ROBERT MCLIMANS  
1213 OHIO STREET  
NAPOLEON OHIO  
REMODEL GARAGE ROOF  
DRAWN BY: DON MOORHEAD

W-1

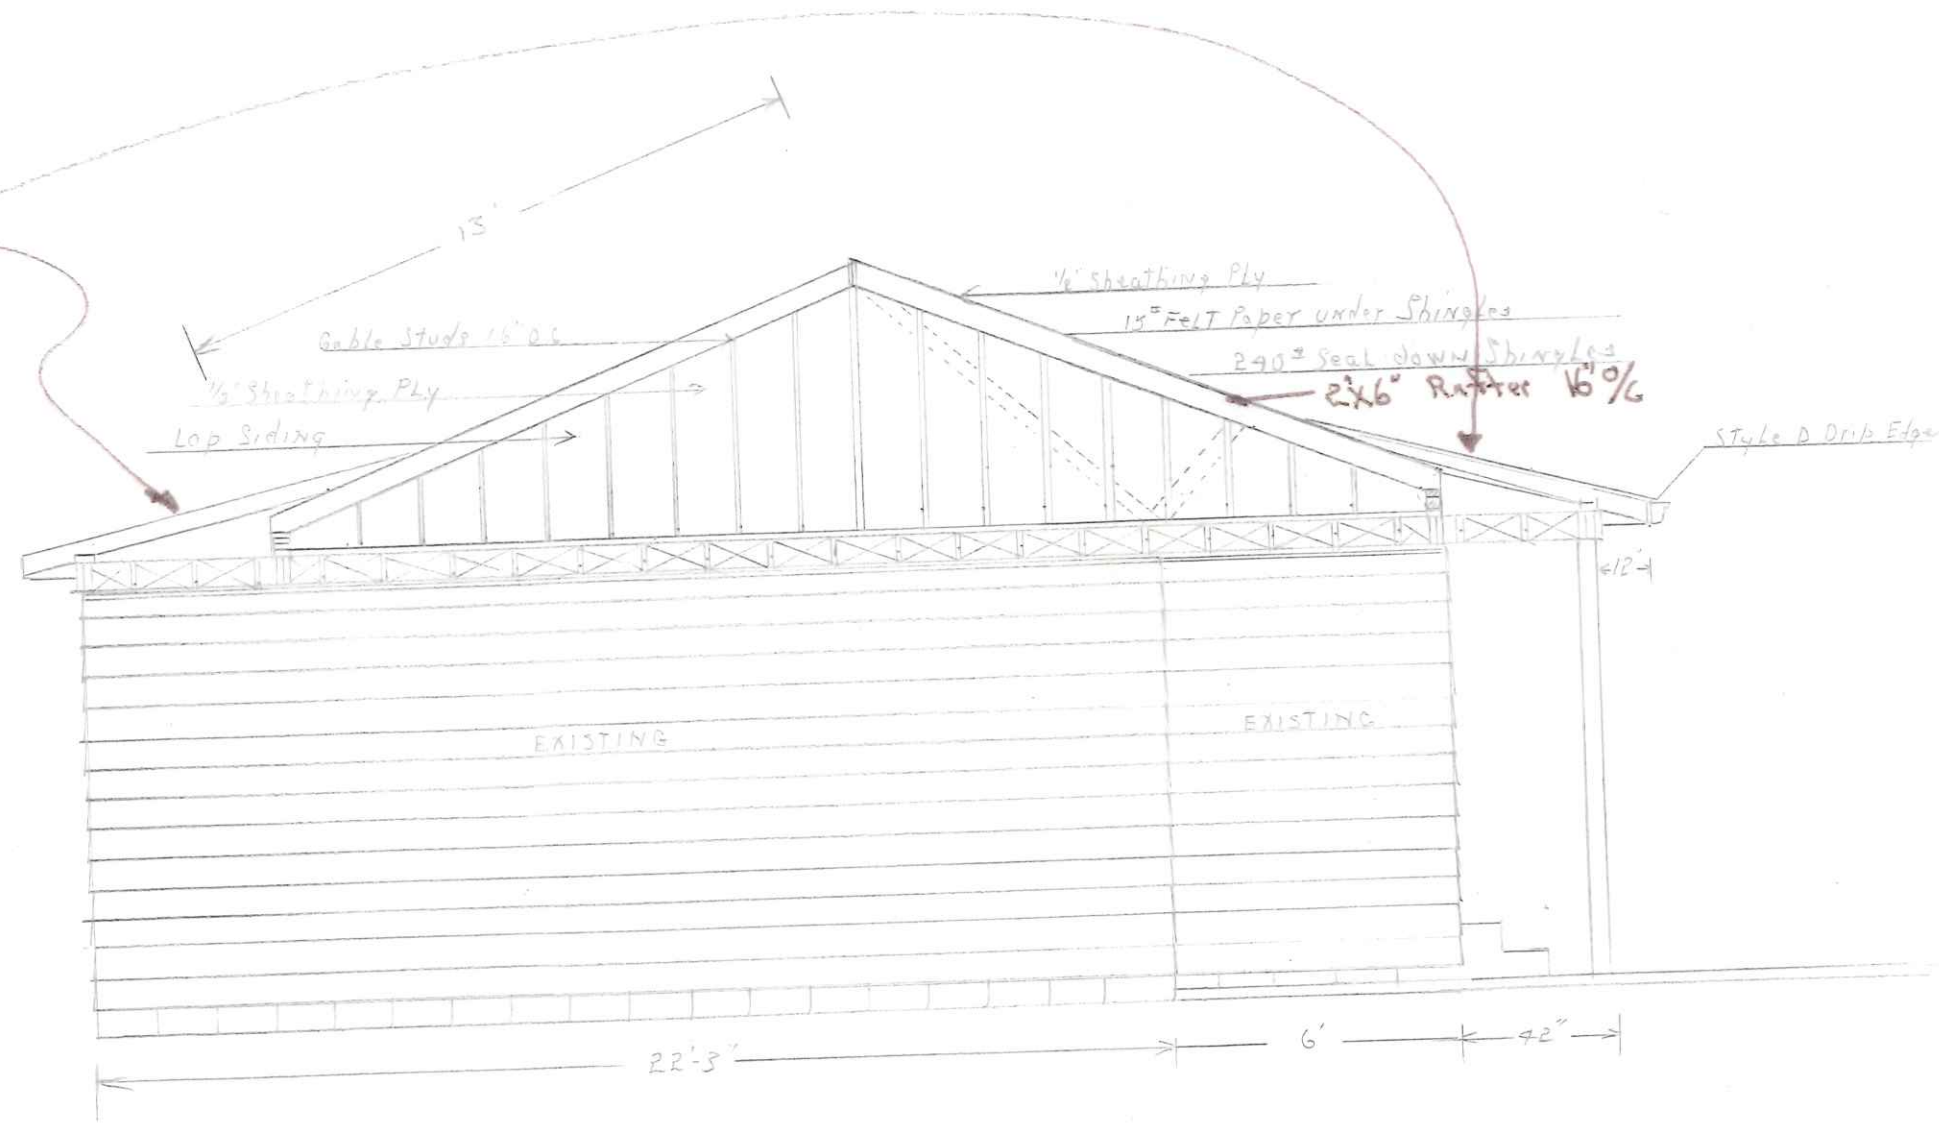
Note: Maintain  
4/12 slope or  
better.  
A.W.P.

Note: 9/2/75  
informed by owner  
42" overhang existing.  
D.M.P.
